TITLE 38 ADDENDUM NO. 3

PROPOSAL FOR FURNISHING ALL LABOR, MATERIALS, EQUIPMENT, TRANSPORTATION, SUPERVISION, PERMITS, ETC. NECESSARY FOR NIRC BUILDING 10B MODIFICATIONS LOCATED ON THE UL LAFAYETTE CAMPUS, NEW IBERIA, LOUISIANA.

Due March 28, 2023, 2:00 PM Solicitation No. 23231

BUILDING 10B - PARTIAL 1ST FLOOR CONCRETE LAYOUT

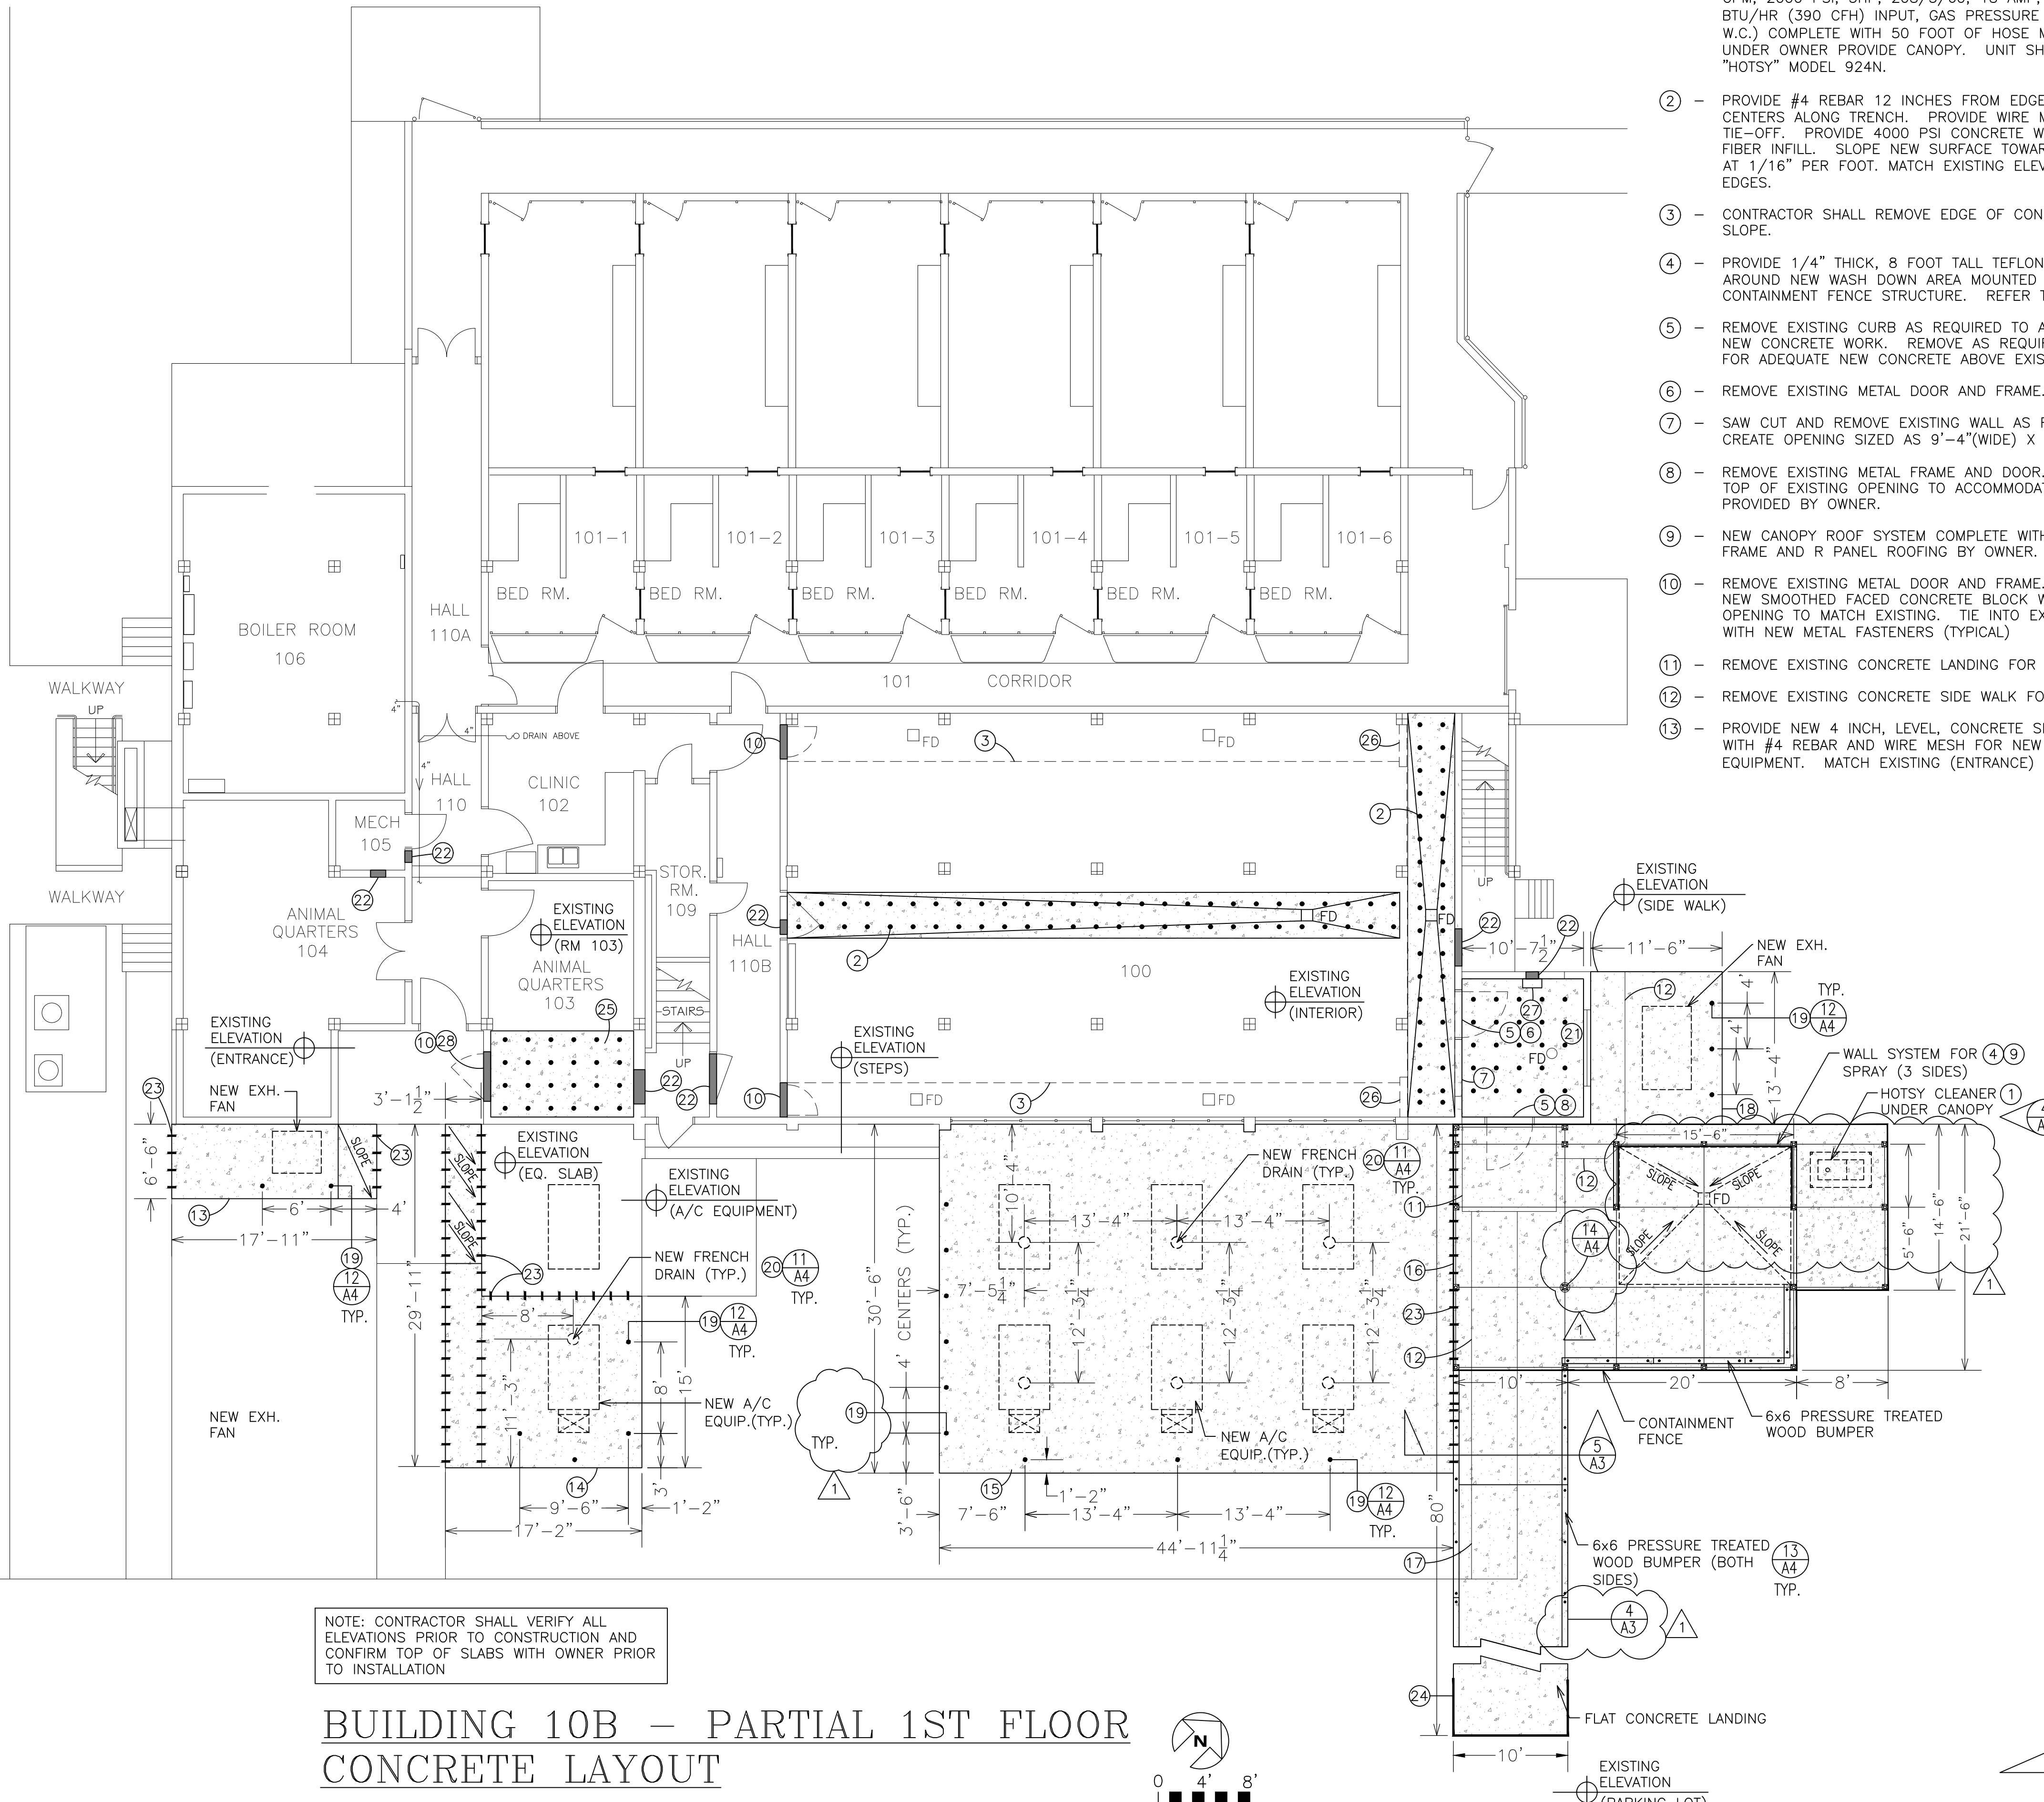
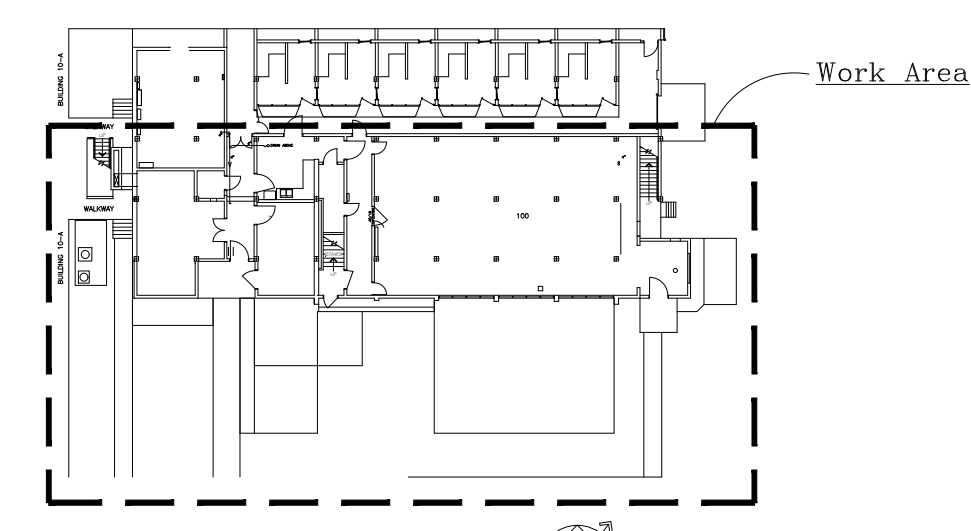
Refer to Sheet A1, replace sheet with revised sheet dated 3/24/23.

21 ANIMAL WATERING CONNECTION DETAIL

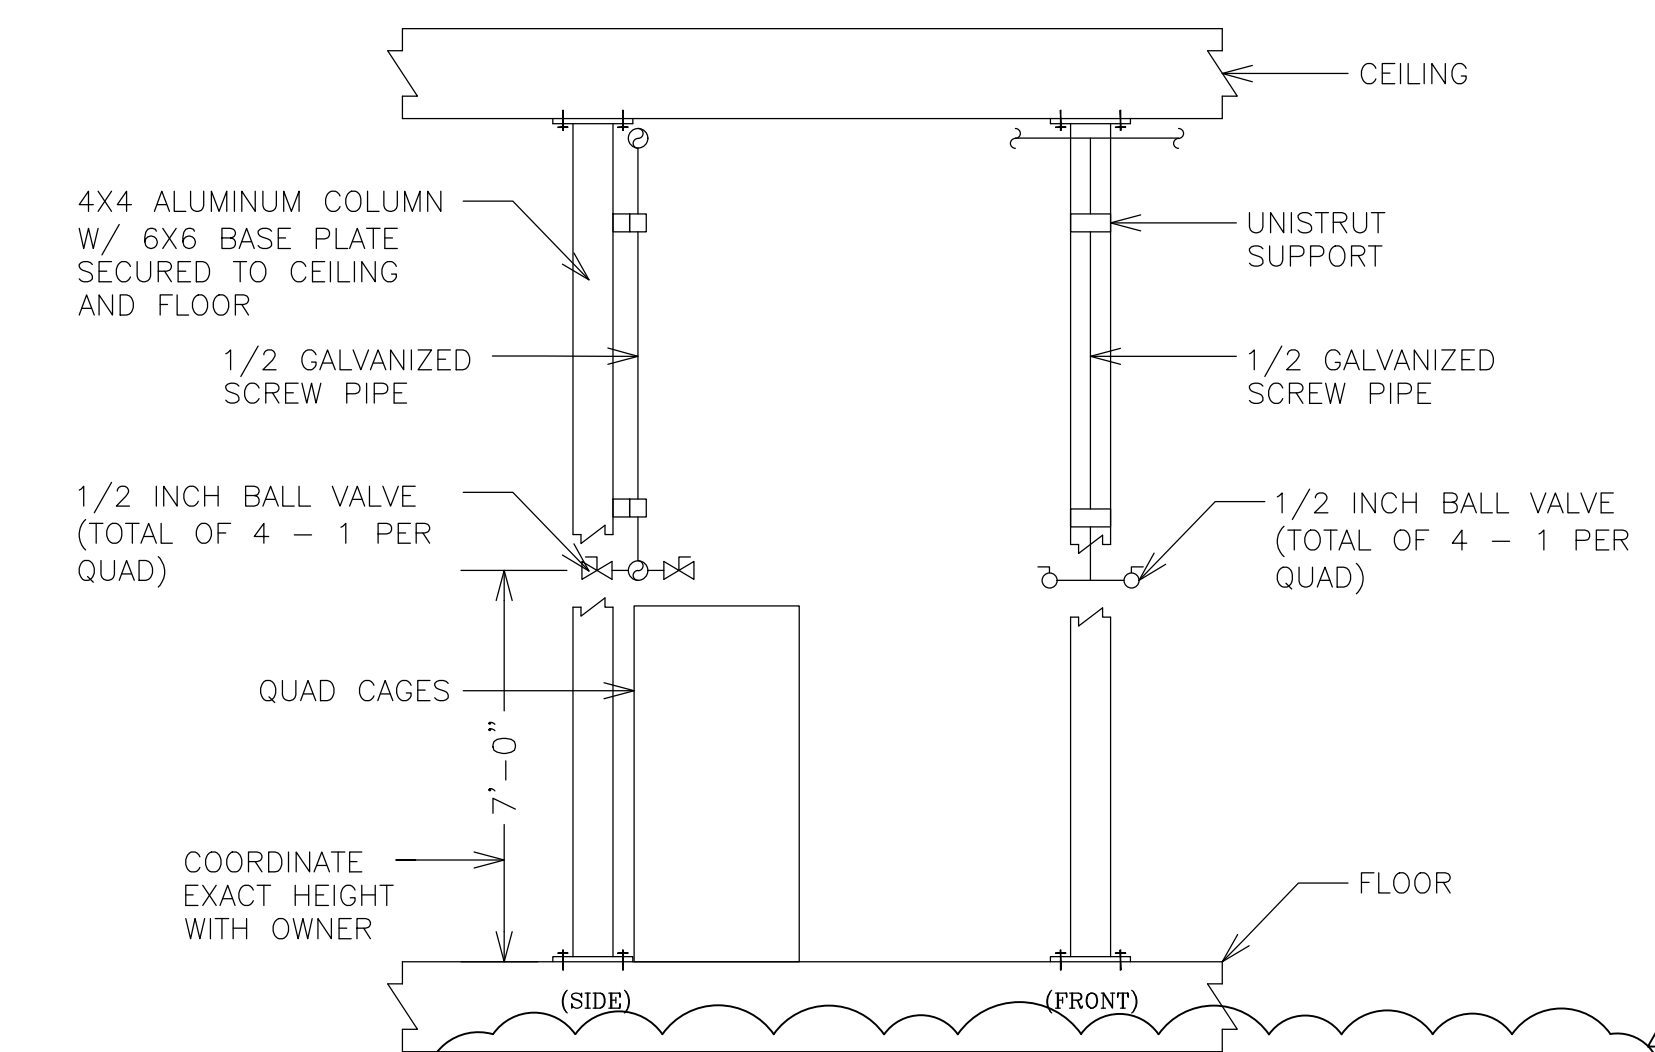
Refer to Sheet A4, detail marked 12 "BOLLARD DETAIL", after detail 20 – Change to 21 "ANIMAL WATERING CONNECTION DETAIL".
